Zenair Europe

Service Letter

S.L. Number:	ZE-2009-01
Date of issue:	June 1, 2009
Subject:	Verification of the proper installation of the “Flap Stops” (Part N° 6S3-1)
Affected Models:	All Zenair Zodiac CH 601XL/CH 650 (ULM and Homebuilt Models).
Serial Number(s)	All
Manufactured by:	Czech Aircraft Works (CZAW) and others.
Purpose:	The purpose of this S.L. is to ensure that all affected models are only flown when “Flap Stops” are installed.
Directed Action(s):	<p>a) Before the next flight, inspect the outboard area of the flap gaps on the top surface of each wing, to establish that the “Flap Stops” have been properly installed (see illustrations on page 2).</p> <p>b) When properly installed, the flaps come to rest against the “Flap Stops” when in the “up” (retracted) position. There should be no free-play at the trailing edge of the flaps when flaps are in the “up” position (snug against the Flap Stop).</p> <p>c) If not installed (see photo below), obtain and install the missing parts according to this S.L. before the next flight.</p> <div data-bbox="764 1274 1212 1536" data-label="Image"> </div>

Left flap shown in “down” position

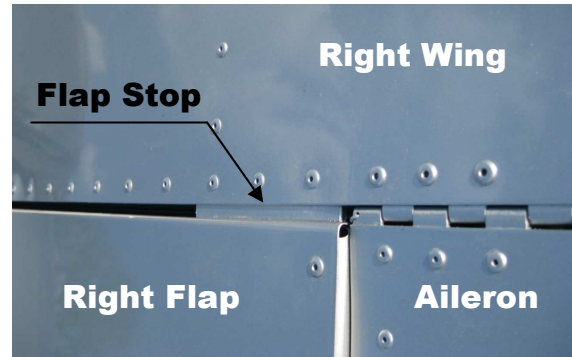
1) When in the “up” position, the flap must rest against a plastic “flap stop” (see photos below). Both left and right flaps must be touching the stops when flaps are retracted (“up”).

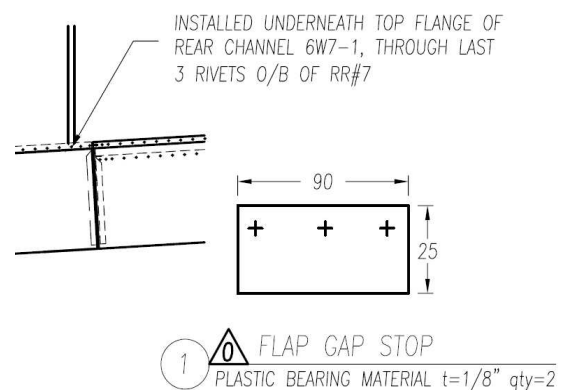
2) There should be no free-play in the flaps when they are in the “up” position (test by applying light up-then-down pressure to the trailing edge). When flap stop (6S3-1) is installed as illustrated, no further action is necessary.

3) If Flap Stops are missing, order and install the parts by first drilling out the three corresponding rivets at trailing edge; position the plastic stops so that flaps just touch them in the up position and tape in place. Use existing rivet holes to position drill bit (#20 or 4mm) and drill through plastic. Remove tape and any burrs, rivet in place with three A5 Avex rivets or equivalent. Apply desired finish. Caution: If using Zenair-supplied rivets, the correct riveter-head must be used on the riveting tool!
